**KNOXVILLE/KNOX COUNTY METROPOLITAN PLANNING COMMISSION
CITY OF KNOXVILLE CLOSURE OF PUBLIC RIGHT-OF-WAY**

▶ **FILE #:** 8-C-13-SC

▶ **RIGHT-OF-WAY TO BE CLOSED:** Chamique Holdsclaw Dr

▶ **LOCATION:** Between Lake Loudoun Boulevard and Pat Head Summit Street

File No. 8-C-13-SC CLOSURE OF Chamique Holdsclaw Dr (Electric)

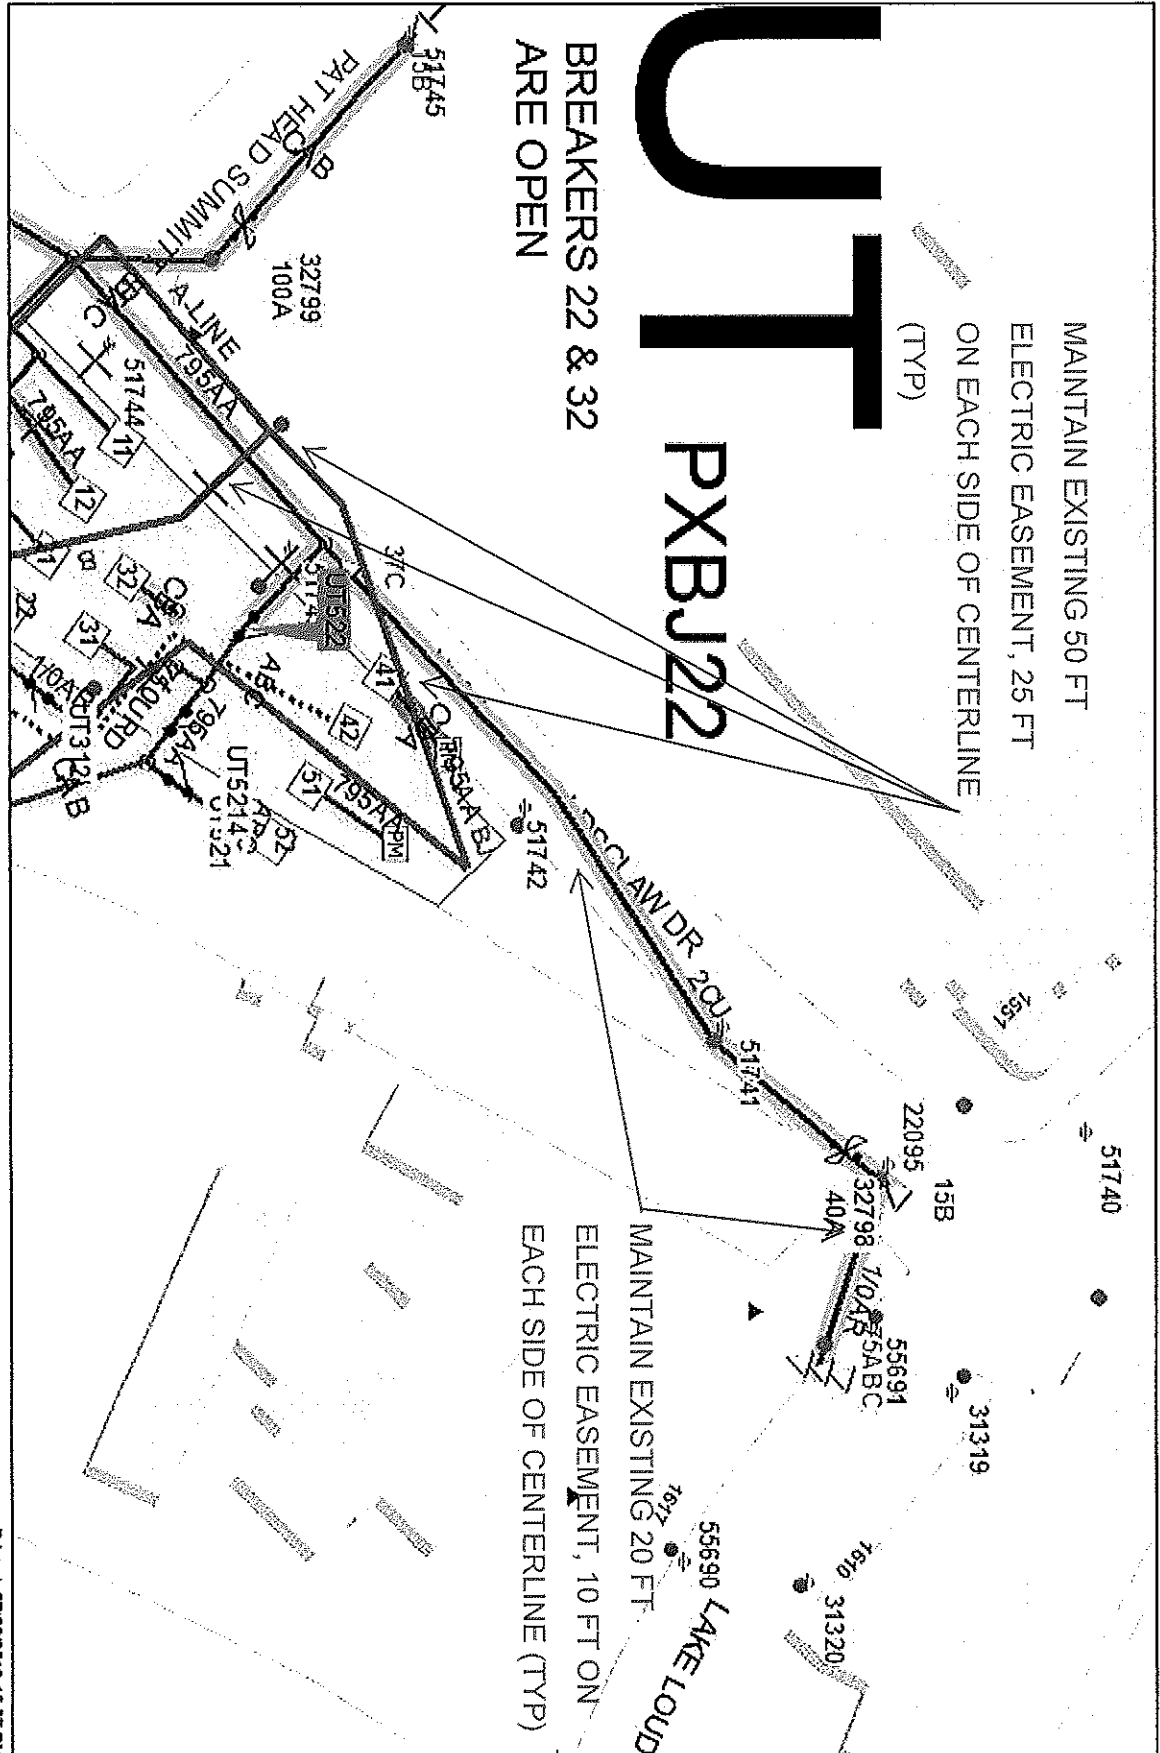
MAINTAIN EXISTING 50 FT
ELECTRIC EASEMENT, 25 FT
ON EACH SIDE OF CENTERLINE
(TYP)

MAINTAIN EXISTING 20 FT
ELECTRIC EASEMENT, 10 FT ON
EACH SIDE OF CENTERLINE (TYP)
